Re: Letts Drop Forge – April 5 meeting

The Detroit Water and Sewerage Department ("Department") wishes to summarize its comments to our discussion of the above referenced facility during the meeting of April 5, 2000. It is our desire to have remedial actions occur to minimize further impact of the Detroit sewer system from the release of PCB and other contaminants from the Letts Drop Forge site.

DRAWING 1

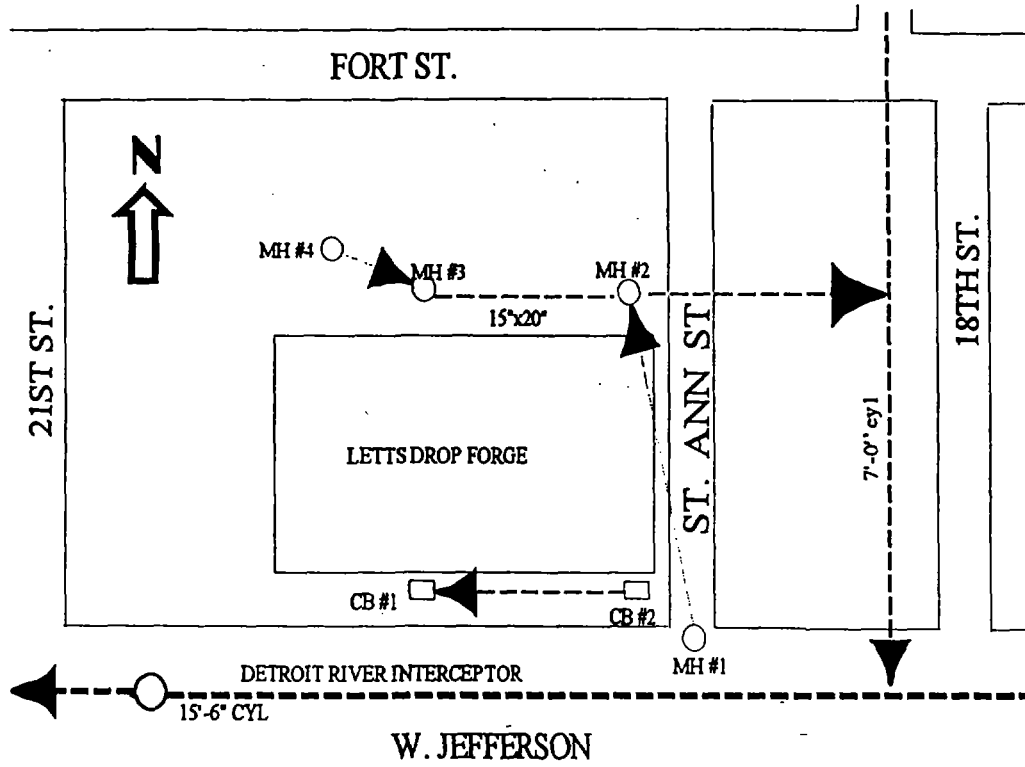
1. Cleaning of the sewer system servicing the facility which includes at a minimum (See attached schematic sewer drawing):
 - (i) Clean and remove all sludge and organic material followed by a powerwash of Catchbasin CB#1, CB #2 and all other catchbasins and sumps inside the company property and the pipes connecting those to the sewer line in the alley south of the facility.
 - (ii) Clean and remove all sludge and organic material followed by a powerwash of the alley sewer from the manhole MH #4 at the west end to the outfall at 7'-0" sewer at the east end that runs through the alley west of 18th street including all manholes on it.
 - (iii) Clean and remove all sludge and organic material followed by a powerwash of Manhole MH #1 on Jefferson at the south –east corner of the facility and the sewer pipe connecting the manhole to the sewer line in the alley south of the facility.

During the cleaning, reasonable efforts must be taken to prevent any solid or oily residues from being dumped into the Jefferson interceptor. These materials are to be properly disposed of in accordance with US EPA requirements.

Please be advised that the Sewer cleaning plan shall be subject to approval by both DWSD Industrial Waste Control and DWSD Sewer Maintenance and Repair section.

No liquid or solid waste generated during the sewer cleaning will be allowed to be discharged into the sewer.
